UNITED STATES PATENT AND TRADEMARK OFFICE

Office Action Summary

09/998,944

Office Action

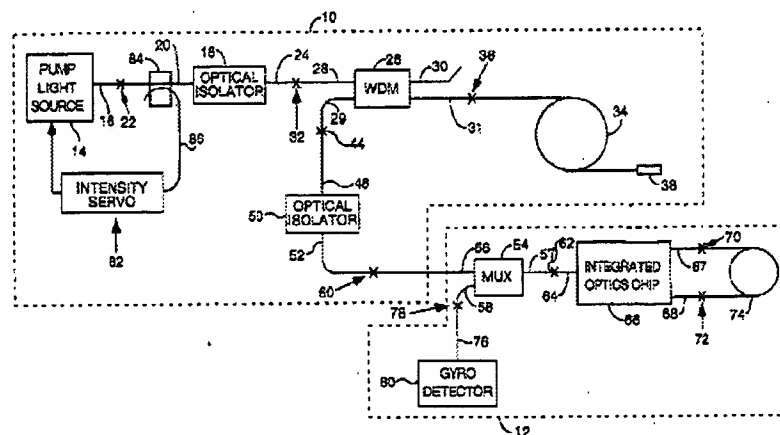
Rozelle et al teach a Sagnac sensor comprising a fiber pumped source(10), wavelength division multiplexer(54), integrated optics chip(66), fiber coil(74), and detector(80). optical isolators(18,50) are used to isolate the pump source from the fiber laser(34) while the isolator(50) isolates the fiber laser from the sensor output.

It would have been obvious to one of ordinary skill in the art at the time the invention was made to isolate various optical sources which would include and optical amplifiers from the output of previous optical elements. In the case of Sakuma it would have been obvious to position an isolator between the optical amplifier and the first coupler in order to isolate the sensor from the output from the optical amplifier which would then be seen as noise.

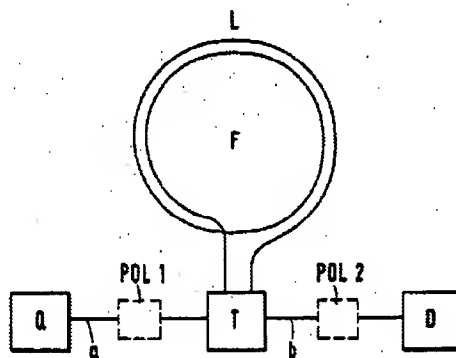
This reference teaches placing a polarizer(POL2) at the detector(D) in order to pass only the desired polarization and thus further eliminating polarization crosstalk from the fiber coil and increasing accuracy.

It would have been obvious to one of ordinary skill in the art at the time the invention was made to modify the Sakuma sensor by placing a polarizer at the detector in order to pass only the desired polarization and thus further eliminating
